# Journey 3

## Hardware Reference Design

## Errata

Rev. 0.4

Figure 2-1 Journey 3 integrated ESD protection

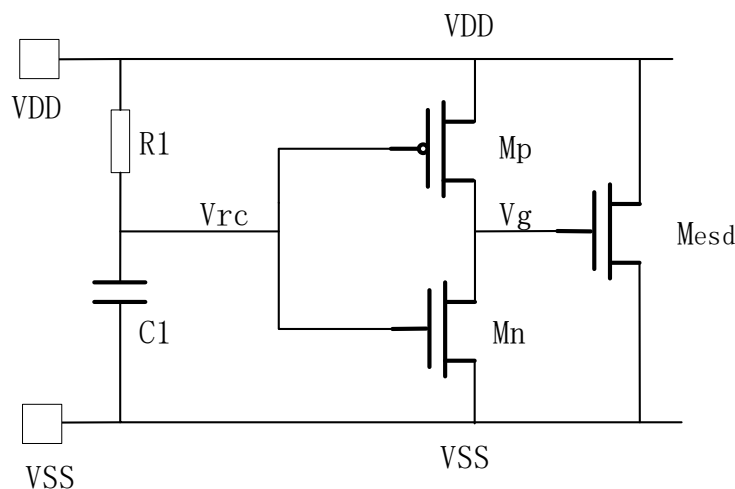
Some of the Power rails of Journey 3 integrate a typical ESD protection circuit depicted by the following figure.

When VDD ramp up too fast (ESD transient), the RC delay circuit will keep Vrc low and Vg high, then Mesd will be opened to sink the ESD transient to VSS.

However, if normal power up event has too fast ramp up rate, it will mis-trigger the Mesd and has the very small potential to damage the Mesd after numerous power-up events.

Regarding the Journey 3 reference design, the failed power rail is VAA and PVT\_VDDA\_TAVDD. The actual measured ramp up rate is around 30mV/us.

Figure 2-2 Ramp up rate control circuit

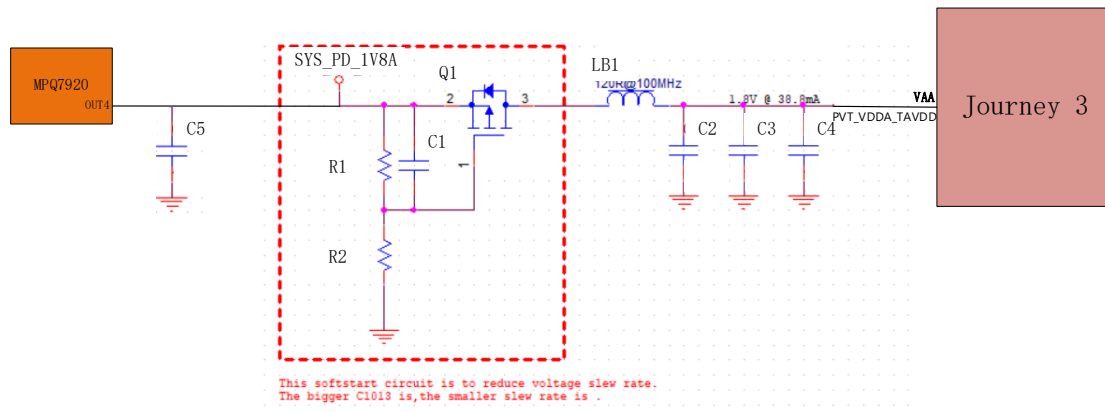
- One option is to use a discrete LDO power supply which has < 5mV/us ramp up rate.
- The 2<sup>nd</sup> option is to use the following soft start circuit between the LDO output and VAA.

1. select Q1 with small  $R_{ds(on)}$  ( $< 200m\Omega$ ) and continuous  $I_d$  drain current  $> 200mA$
2. Make sure voltage feed into VAA still meets the ripple requirement ( $1.8V \pm 2.5\%$ )
3. Adjust the value of C1 to achieve  $< 5mV/\mu s$  ramp up rate.

Figure 2-3 External POR reset circuit

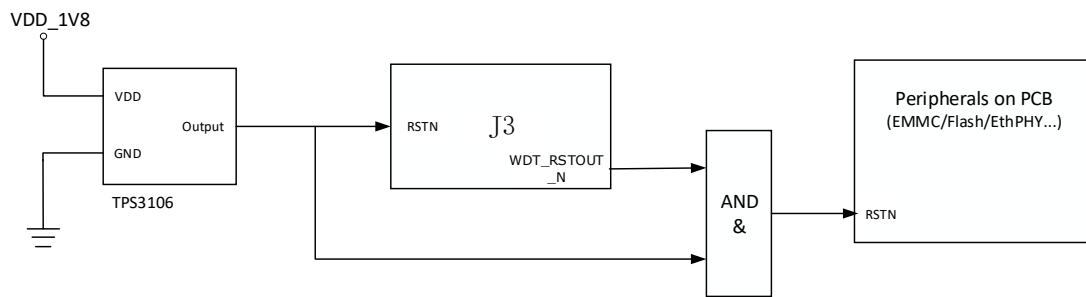
Journey 3 needs external Power-On-Reset (POR) input through RSTN pin to reset the entire chip. The RSTN should be stable more than 10ms after all the power groups (1/2/3/4) achieve target value and 24MHz main clock is active and stable.

Figure 2-3 shows the recommended connection of external POR circuit.

**Note:** WDT\_RSTOUT\_N signal needs to be sent to peripherals on the board especially memory devices (EMMC and Flash) and can't be sent back to J3's RSTN input signal via PCB trace.

Figure 2-4 CNN Power supply transient voltage drop

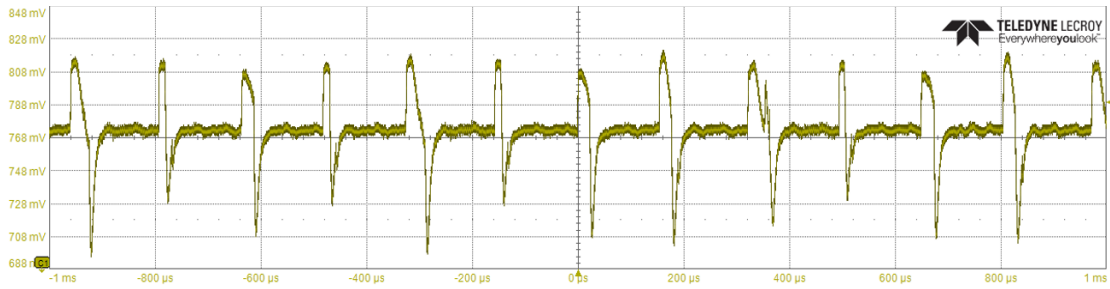
Because Journey3's CNN behavior causes much higher  $di/dt$  (current variation over time) than other core power supply, the power supply to CNN core needs to have better transient load response performance. Otherwise, transient voltage drop will occur on VRM's output. Please check the following figure for this phenomenon.

- ◆ First way is to choose a DCDC/PMIC with better transient load response performance, the following table depict a reference requirement for DCDC/PMIC transient load response.

- ◆ 2<sup>nd</sup> way is to increase Cout to BIGGER value if the PCB space could accommodate the extra component. The following table gives some reference part number which could be used. Customer could choose their own part number with enough capacitance and small ESR.

Figure 2-6 J3 DVB LPDDR4 Power Off Sequence

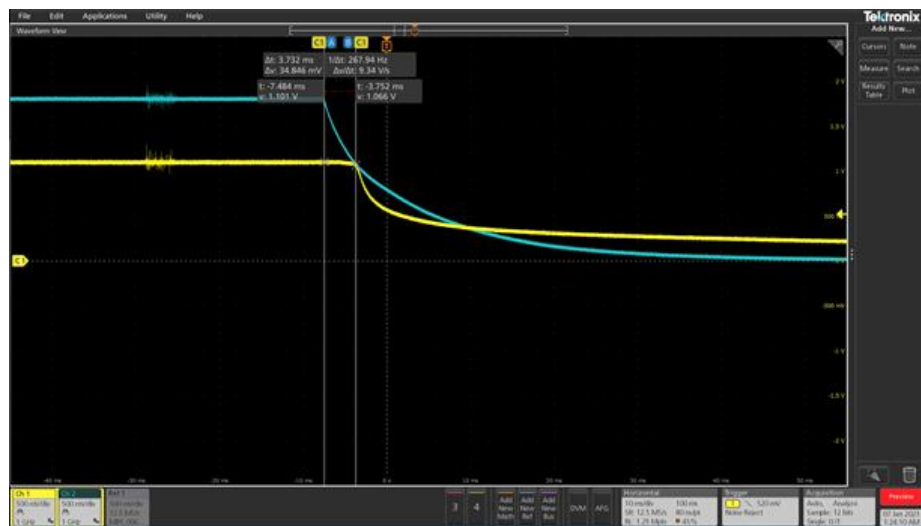
J3 DVB does not meet this requirement. The power ramp and off sequence are as the Figure 2-5 and Figure 2-6.

**Note:** the yellow curve is 1.1V (VDDQ and VDD2), the blue curve is 1.8V (VDD1), the light green curve is 5V (input to the PMIC).

Figure 2-9 Power Ramp after Workaround

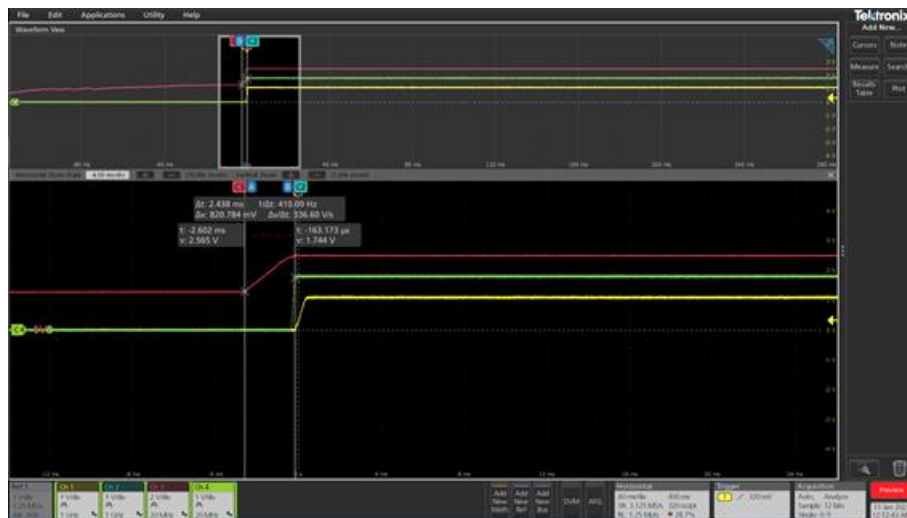
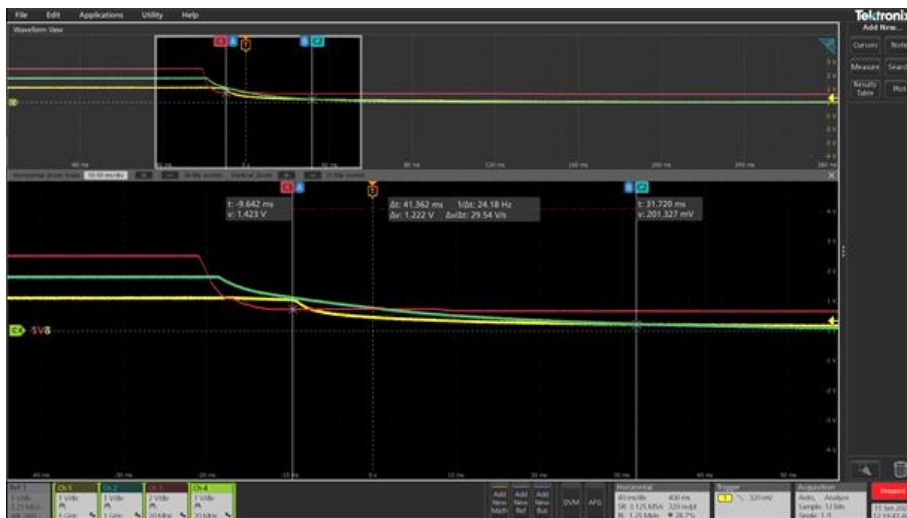
After the workaround, the power ramp/off waveform are as the Figure 2-9 and Figure 2-10.

**Note:** the yellow curve is 1.1V (VDDQ and VDD2), the green curve is 1.8V (VDD1), the red curve is 5V (input to the PMIC).

Figure 2-11 VBUS Insertion Detection Solution

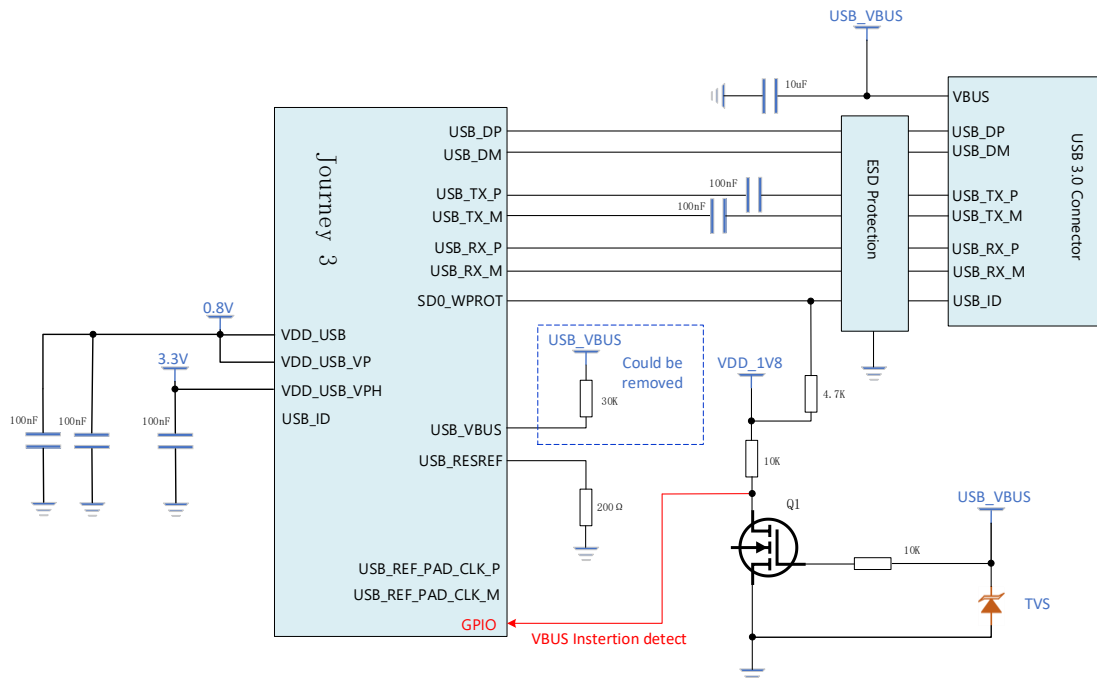
USB\_VBUS pin is not functional available at the package ball. The 30K  $\Omega$  pull up resistor is no longer needed, and the VBUS detection is also not available through USB\_VBUS pin.

**Solution A:** use a separate GPIO to detect the VBUS insertion. Please refer to the Figure 2-11 for the detail connection. Dedicated software thread is needed for GPIO status polling.
